Access Compliance Report Public Rights-of-Way (Curb Ramps)

ADA ID: RPRK211020175209 Ramp Type: Type 4 - Parallel Initial Pass/Fail: Pass Overall Compliance: No Severity Score: 26

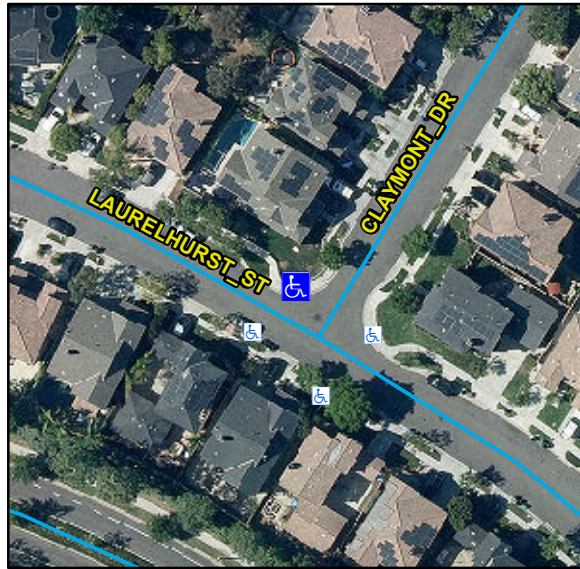
Compliance	Description	Data	Compliance	Description	Data
N/A	Ramp Length LT (in)	111	N/A	Ramp Length RT (in)	110
Yes	Ramp Width LT (in)	53	Yes	Ramp Width RT (in)	53
Yes	Ramp Run Slope LT (%)	4.7	Yes	Ramp Run Slope RT (%)	5.4
Yes	Ramp Cross Slope LT (%)	2	Yes	Ramp Cross Slope RT (%)	0.5
N/A	Landing Present	No	No	DWS Provided	No
N/A	Landing Length (in)	N/A	N/A	DWS Contrast	N/A
No	Landing Width (in)	N/A	N/A	DWS Length (in)	N/A
No	Landing Run Slope (%)	N/A	N/A	DWS Full Width	N/A
No	Landing Cross Slope (%)	N/A		DWS Offset Type	N/A
N/A	Landing Movement Obstructed?	No	N/A	DWS Offset Left (in)	N/A
	Landing Movement Type	Curb	N/A	DWS Offset Right (in)	N/A
N/A	Landing Shared	N/A			
N/A	Clear Space	Yes			
N/A	Clear Space To Crosswalk (in)	48			
N/A	Marked Crosswalk 1	No	N/A	Marked Crosswalk 2	No
	Crossing 1 Direction	SW		Crossing 2 Direction	SE
	Marked Crosswalk 1 Width (in)	N/A		Marked Crosswalk 2 Width (in)	N/A
N/A	Ramp Inside Crosswalk 1	N/A	N/A	Ramp Inside Crosswalk 2	N/A

Crossing 1 Slope (%)	2.5		Crossing 2 Slope (%)	3.5
	Crossing 1 Cross Slope (%)	1		Crossing 2 Cross Slope (%)	0.7
Yes	Gutter Ponding	No	No	Curb Slope	13.3
Yes	Gutter Lip Height (in)	0		Road Run Slope (%)	0.8
No	Gutter Run Slope (%)	7.8		Road Cross Slope (%)	3.8
Yes	Gutter Cross Slope (%)	1.3	No	Perpendicular Joint Present	No
Yes	Overall Surface Condition	Acceptable			
	Cross Gutter Present?	No		Spandrel Present?	No
	Replace Cross Gutter?	N/A		Replace Spandrel?	N/A

Remove & Replace Curb Ramp With Two New Directional Ramps or Equivalent. Remove & Replace Gutter.
